23 March 2023

**RE: ADDITIONAL INFORMATION RESPONSE
132a QUEENS PARADE EAST, NEWPORT (DA2022/1425)**

Figure 1: East elevation

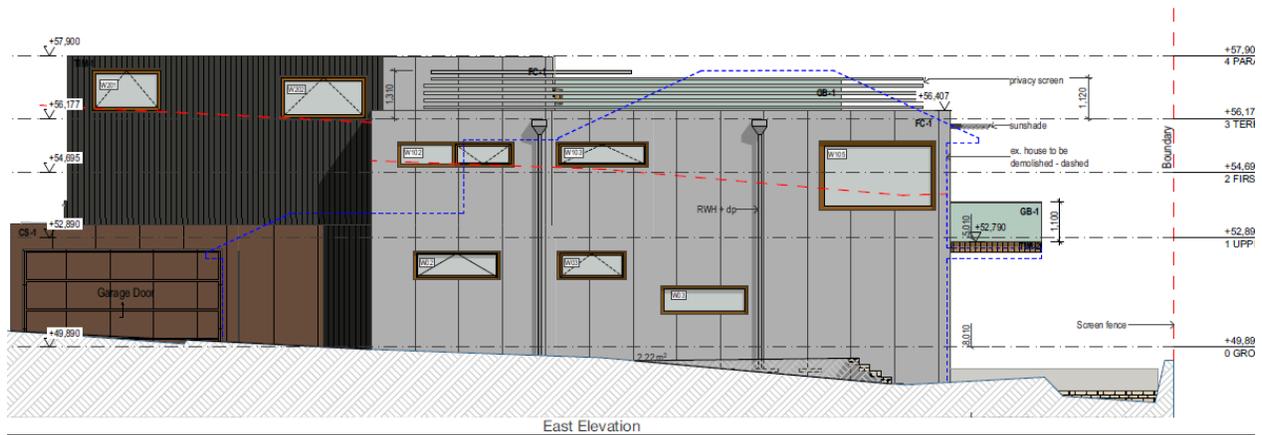
The eastern elevation does breach further down the dwelling towards the rear. We note that the existing dwelling is sited towards the eastern boundary and the outline of the existing dwelling is shown below:

The blue hatch shows the existing dwelling to be demolished (footings retained) and the red hatch line shows the building envelope control. It is considered that the bulk and scale relationship of the proposed dwelling when viewed from No. 134 would not be dissimilar to the existing relationship in terms of its visual impact. The retention of the existing footings does contribute to the extent of the breaches also.
